The Florida Senate
COMMITTEE MEETING EXPANDED AGENDA
COMMUNICATIONS, ENERGY, AND PUBLIC UTILITIES
Senator Grimsley, Chair
Senator Hukill, Vice Chair

MEETING DATE: Friday, April 29, 2016
TIME: 4:00—8:00 p.m.
PLACE: F-222, Miami Dade College, Homestead Campus

Turkey Point Cooling Canal System Update

Figure 9: Temperature differences between CCS and overlying air. Horizontal lines show intervals of constant heat-addition rates.

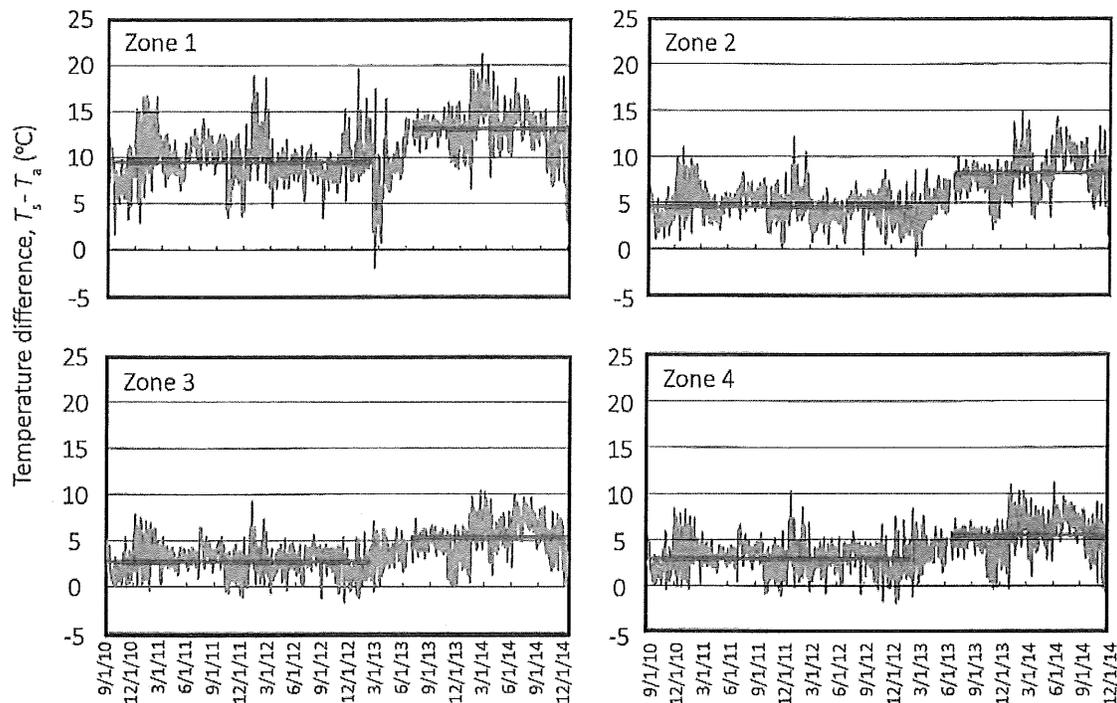
in Figure 9, where the average temperature difference during Period 1 and Period 2 are shown as horizontal lines. It is apparent from Figure 9 that the increase in the average heat-rejection rate from Period 1 to

Period 2 corresponds to an increase in the average value of $T_s - T_a$. Representing the average value of $T_s - T_a$ during Period 1 as $\overline{\Delta T}_1$ and the average value of $T_s - T_a$ during Period 2 as $\overline{\Delta T}_2$, these averaged values for each CCS zone are shown in Table 2, along with the corresponding standard deviations, S_1 and S_2 , respectively. These results show that in Zone 1, which accepts the cooling-water discharge, the average temperature difference between the CCS and the overlying air has increased from 9.6°C (18°F) to 13.1°C (23.6°F), which corresponds to an average temperature increase of 3.5°C (6.3°F). In Zone 4, which contains the cooling-water intake, the average temperature difference between the CCS and the overlying air has increased from 2.8°C (5.0°F) to 5.4°C (9.7°F), which corresponds to an average temperature increase of 2.6°C (4.7°F). These changes in average temperature can be contrasted with previous (pre-uprate) predictions made by FPL's engineering consultants in 2008 where it was anticipated that the uprate of Units 3 and 4 would cause a maximum temperature increase of 1.4°C (2.5°F) in the discharged cooling water (to Zone 1) and an increase of 0.5°C (0.9°F) in the temperature of the intake water (from Zone 4). The standard deviations of the temperature fluctuations are similar across all zones, and have shown relatively modest decreases between the pre-uprate and post-uprate periods. Of particular interest, in Zone 1 the standard deviation decreased from 3.8°C (6.8°F) to 3.3°C (5.9°F), and in Zone 4 the standard deviation decreased from 3.9°C (7.0°F) to 3.5°C (6.3°F).

Figure 17: Differences Between L-31E Canal and CCS Water Levels. The historical difference is in blue, the projected 2015 difference is in orange, and the projected 2016 difference is in gray.

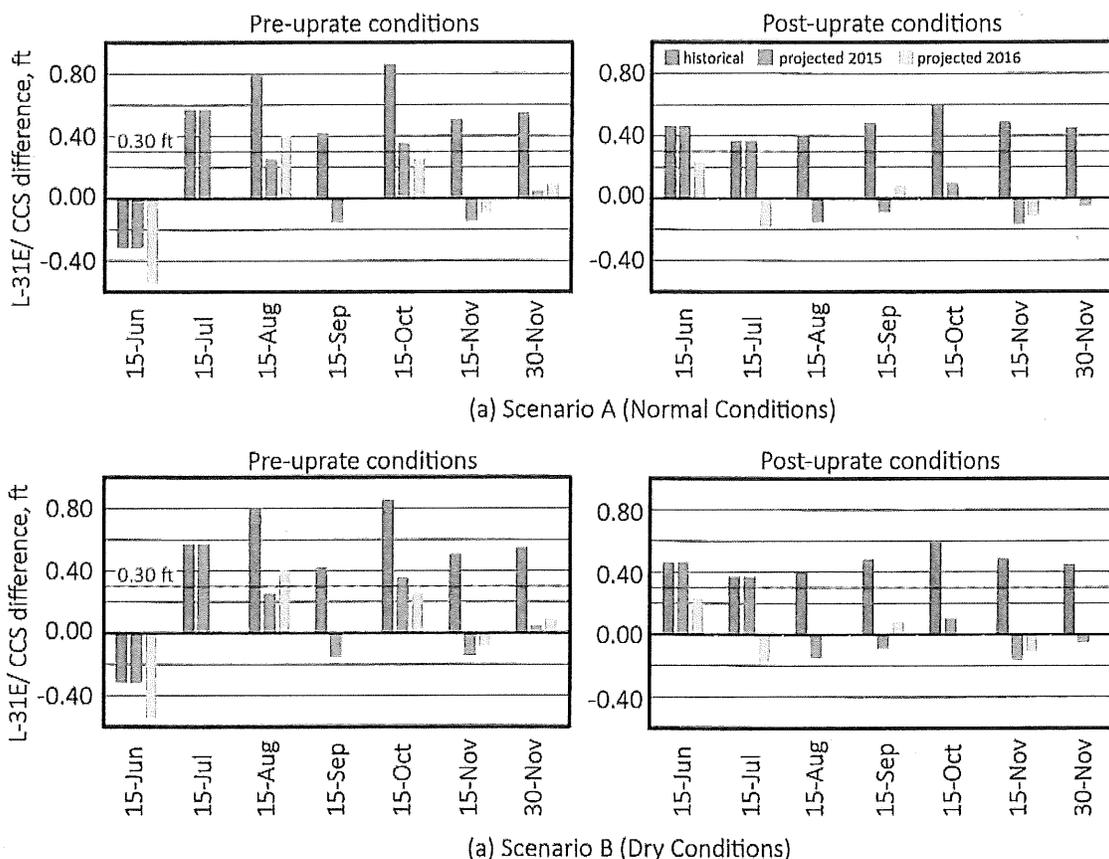
Demonstration of effects. The increases in the water-surface elevations in the CCS predicted by the FPL mass-balance model can be subtracted from the historical water-level differences between the L-31E Canal and the CCS to estimate the water-level differences between the L-31E Canal and the CCS that are likely to exist as a consequence of pumping a maximum of 100 mgd from the L-31E Canal into the CCS. These expected water-level differences are summarized for the Scenario A (the “normal” condition) in Figure 17(a), and for Scenario B (the “dry” condition) in Figure 17(b). For each historical period (pre-uprate and post-uprate), and for each selected day, three water-level differences are shown: the historical difference (blue), the projected 2015 difference (orange), and the projected 2016 difference (gray). In general, the 2015 and 2016 projected water-level differences are less than the historical differences by the amounts listed in Table 4. Also shown in Figure 17 is the 0.30-ft reference line, which is the threshold water-level difference below which the ID pump system is triggered. It is apparent from Figure 17(a) that under pre-uprate water-level-difference conditions a landward water-level gradient would be created around 15-Sep and 15-Nov on which dates there were previously seaward water-level gradients; the 15-Jun data point is anomalous in that a landward gradient already existed in the historical record. It is further apparent from Figure 17(a) that under post-uprate water-level-difference conditions a landward water-level gradient would be created around 15-Jul, 15-Aug, 15-Sep, 15-Nov, and 30-Nov on which dates there were previously seaward gradients. Under both historical conditions (pre-uprate, post-uprate) shown in Figure 17(a), the difference between the water level in the L-31E Canal and the CCS would fall below the 0.30-ft threshold on all of the dates cited in Figure 17(a). Considering Scenario B (the “dry” condition) shown in Figure 17(b), the results are similar to those shown in Figure 17(a). Under pre-uprate conditions, a landward water-level gradient would be created around 15-Sep and 15-Nov, and under post-uprate water-level-difference conditions a landward water-level gradient would be created around 15-Jul, 15-Aug, 15-Sep, 15-Nov, and 30-Nov. Under both historical conditions, the difference between the water levels in the L-31E Canal and the CCS would fall below the 0.30-ft threshold on all dates cited in Figure 17(b). The results shown in Figure 17 collectively show that

Figure 11: Temperature differences between CCS and overlying air. Horizontal lines show intervals of constant heat-addition rates.

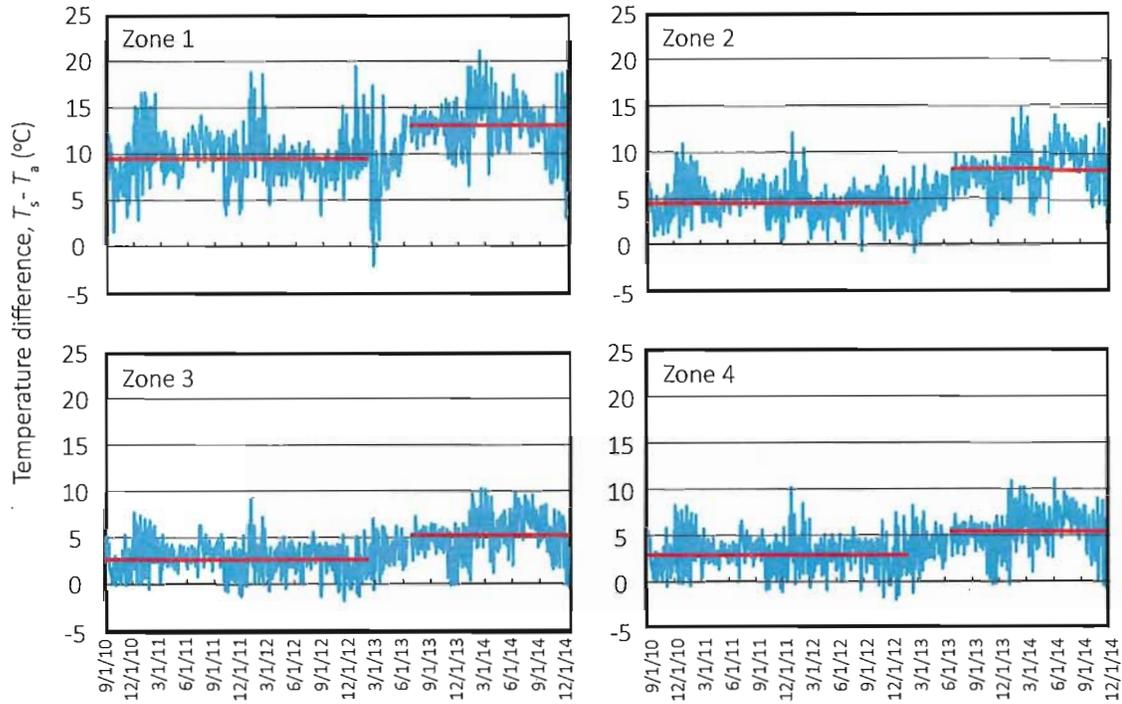
Relationship between increased net heat flux and temperature. An increased heat-rejection rate would normally be expected to increase the temperature in the CCS relative to the temperature of the overlying air. Representing the temperature in the CCS as T_s , and the temperature of the overlying air as T_a , this temperature difference is $T_s - T_a$. The variation of $T_s - T_a$ as function of time for each of the four CCS zones is shown in Figure 11, where the average temperature difference during Period 1 and Period 2 are shown as horizontal lines. It is apparent from Figure 11 that the increase in the average heat-rejection rate from Period 1 to Period 2 corresponds to an increase in the average value of $T_s - T_a$. Representing the average value of $T_s - T_a$ during Period 1 as $\overline{\Delta T}_1$ and the average value of $T_s - T_a$ during Period 2 as $\overline{\Delta T}_2$, these averaged values for each CCS zone are shown in Table 2, along with the corresponding standard deviations, S_1 and S_2 , respectively. These results show that in Zone 1, which accepts the cooling-water discharge, the average temperature difference between the CCS and the overlying air has increased from 9.6°C (17.3°F) to 13.1°C (23.6°F), which corresponds to an average temperature increase of 3.5°C (6.3°F). In Zone 4, which contains the cooling-water intake, the average temperature difference between the CCS and the overlying air has increased from 2.8°C (5.0°F) to 5.4°C (9.7°F), which corresponds to an average temperature increase of 2.6°C (4.7°F). These changes in average temperature can be contrasted with previous (pre-uprate) predictions made by FPL's engineering consultants in 2008 where it was anticipated that the uprate of Units 3 and 4 would cause a maximum temperature increase of 1.4°C (2.5°F) in the discharged cooling water (to Zone 1) and an increase of 0.5°C (0.9°F) in the temperature of the intake water

Figure 20: Differences Between L-31E Canal and CCS Water Levels. The historical difference is in blue, the projected 2015 difference is in orange, and the projected 2016 difference is in gray.

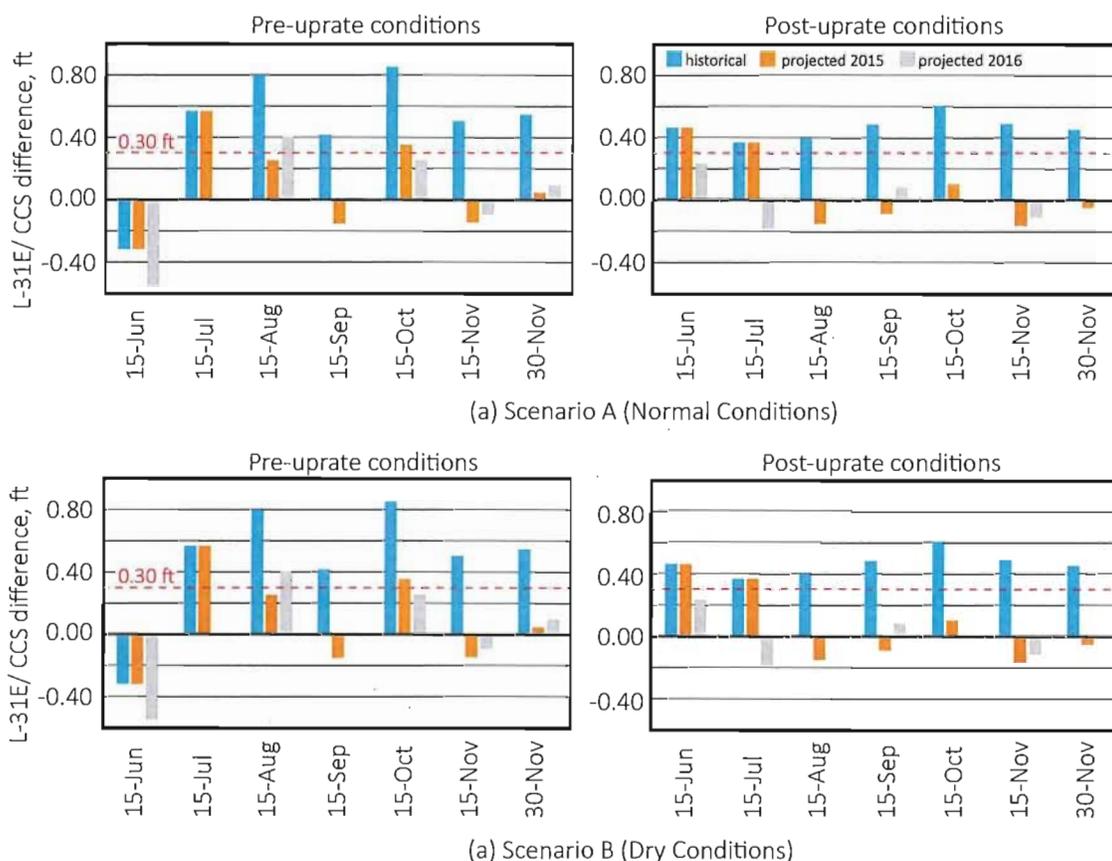
to exist as a consequence of pumping a maximum of 100 mgd from the L-31E Canal into the CCS. These expected water-level differences are summarized for the Scenario A (the “normal” condition) in Figure 20(a), and for Scenario B (the “dry” condition) in Figure 20(b). For each historical period (pre-uprate and post-uprate), and for each selected day, three water-level differences are shown: the historical difference (blue), the projected 2015 difference (orange), and the projected 2016 difference (gray). In general, the 2015 and 2016 projected water-level differences are less than the historical differences by the amounts listed in Table 5. Also shown in Figure 20 is the 0.30-ft reference line, which is the threshold water-level difference below which the ID pump system is triggered. It is apparent from Figure 20(a) that under pre-uprate water-level-difference conditions a landward water-level gradient would be created around 15-Sep and 15-Nov on which dates there were previously seaward water-level gradients; the 15-Jun data point is anomalous in that a landward gradient already existed in the historical record. It is further apparent from Figure 20(a) that under post-uprate water-level-difference conditions a landward water-level gradient would be created around 15-Jul, 15-Aug, 15-Sep, 15-Nov, and 30-Nov on which dates there were previously seaward gradients. Under both pre-uprate and post-uprate conditions shown in Figure 20(a), the difference between the water level in the L-31E Canal and the CCS would fall below the 0.30-ft threshold on all of the dates cited in Figure 20(a). Considering Scenario B (the “dry” condition) shown in Figure 20(b), the results are similar to those shown in Figure 20(a). Under pre-uprate conditions, a landward water-level gradient would be created around 15-Sep and 15-Nov, and under post-uprate water-level-difference conditions a landward water-level gradient would be created around 15-Jul, 15-Aug, 15-Sep, 15-Nov, and 30-Nov. Under both pre-uprate and post-uprate conditions, the difference between the water levels in the L-31E Canal and the CCS would fall below the 0.30-ft threshold on all dates cited in Figure 20(b). The results shown in Figure 20 collectively show that there is cause for concern that pumping 100 mgd from the L-31E Canal into the CCS could cause a landward water-level gradient where none previously existed. This concern is further exacerbated when considering that water levels at the northern end of the CCS near the discharge from the power-generating units will

Historical anecdote. Interestingly, in 1978, engineers from the consulting firm Dames and Moore wrote a report to FPL with a specific section in their report titled “Effects of an Overall Increase in Water Level in the Cooling-Canal System Relative to the Ground Water” (Dames and Moore, 1978). In their report, the engineers at Dames and Moore specifically considered the impact of raising the water level in the CCS by 0.50 ft above the water table in the surrounding aquifer. They concluded that such an occurrence would cause the saltwater interface to move approximately one mile further inland relative to its location prior to the rise in the water level of the CCS.
